Access Compliance Report Public Rights-of-Way (Curb Ramps)

Main Street: LA_COLINA_DR		Cross Street: LA_BELLA_DR		Location:	N
ADA ID: RPRK211014135917	Ramp Type:Type 1 - Perpendicular Diagonal Initial Pass/Fail: Fail		Overall Compliance: No	Severity Score:	15

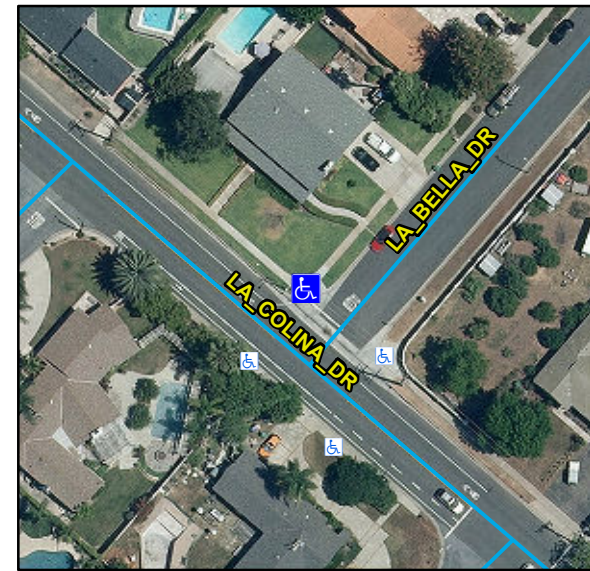
Compliance	Description	Data	Compliance	Description	Data
N/A	Ramp Length (in)	113	N/A	Flare Type LT	
Yes	Ramp Width (in)	48			N/A
No	Ramp Run Slope (%)	8.4	N/A	Flare Slope LT (%)	N/A
Yes	Ramp Cross Slope (%)	0.1	N/A	Flare Traversable LT	N/A
N/A	Landing Present	N/A	N/A	Flare Type RT	
N/A	Landing Length (in)	N/A			N/A
N/A	Landing Width (in)	N/A	N/A	Flare Slope RT (%)	N/A
N/A	Landing Run Slope (%)	N/A	N/A	Flare Traversable RT	N/A
N/A	Landing Cross Slope (%)	N/A	N/A	DWS Provided	N/A
N/A	Landing Movement Obstructed?	N/A	N/A	DWS Contrast	N/A
	Landing Movement Type	N/A	N/A	DWS Length (in)	N/A
N/A	Landing Shared	N/A	N/A	DWS Full Width	N/A
N/A	Clear Space	Yes	N/A	DWS Offset Left (in)	N/A
N/A	Clear Space To Crosswalk (in)	N/A	N/A	DWS Offset Right (in)	N/A
N/A	Marked Crosswalk 1	No	N/A	Marked Crosswalk 2	No
	Crossing 1 Direction	SW		Crossing 2 Direction	SE
	Marked Crosswalk 1 Width (in)	N/A		Marked Crosswalk 2 Width (in)	N/A

N/A	Ramp Inside Crosswalk 1	N/A	Yes	Ramp Inside Crosswalk 2	N/A
	Crossing 1 Slope (%)	3.7		Crossing 2 Slope (%)	4.6
	Crossing 1 Cross Slope (%)	0.8		Crossing 2 Cross Slope (%)	1.7
N/A	Gutter Ponding	N/A	No	Curb Slope	10.5
Yes	Gutter Lip Height (in)	0		Road Run Slope (%)	0.3
N/A	Gutter Run Slope (%)	N/A		Road Cross Slope (%)	1.2
N/A	Gutter Cross Slope (%)	N/A			
Yes	Overall Surface Condition: Acceptable		Yes	Perp Joint Present	Yes
	Cross Gutter Present?	Yes		Spandrel Present?	Yes
	Replace Cross Gutter?	No		Replace Spandrel?	No

Remove & Replace Curb Ramp With Two New Directional Ramps or Equivalent.

R304.2.2, STD 1115
